U.S.S.N. 09/686,742

VERSION WITH MARKINGS TO SHOW CHANGES MADE

In The Specification

FIG. 3A

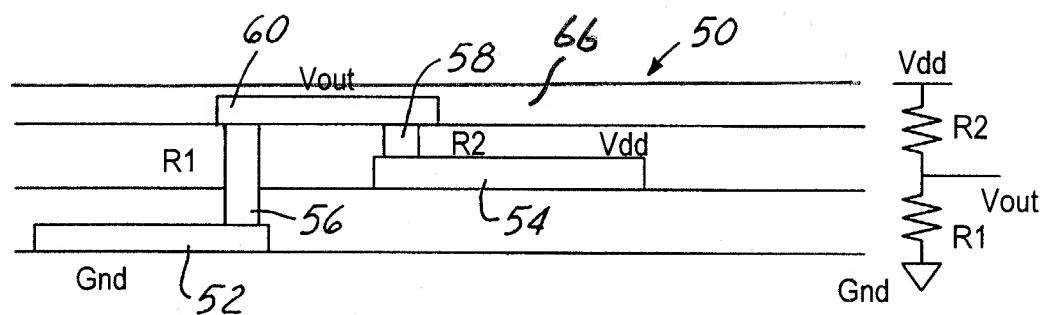
Page 12, after paragraph description for Figure 3, please add the following new paragraph:

Figure 3A is an enlarged, cross-sectional view of another embodiment of the present invention electronic structure having a third insulating layer deposited on top.

Page 23, lines 1-17, has been amended as follows:

In another embodiment of the present invention, more than one level of the electrically resistive vias may be formed and connected to each other. For instance, [while not shown in the drawings,] as shown in Figure 3A, a third insulating material layer 66 may be deposited overlying the second plurality of conductive elements and the second insulating material layer; and then a second plurality of electrically resistive vias that have a resistivity of at least 100 $\Omega\text{-cm}$ may be formed in the

third insulating material layer wherein each of the second plurality of conductive elements is in electrical communication with at least one of the second plurality of electrically resistive vias; and a third plurality of conductive elements is then formed on top of the third insulating material layer each in electrical communication with at least one of the second plurality of electrically resistive vias, whereby at least one of the second plurality of electrically resistive vias is in electrical communication with at least one of the first plurality of electrically resistive vias.
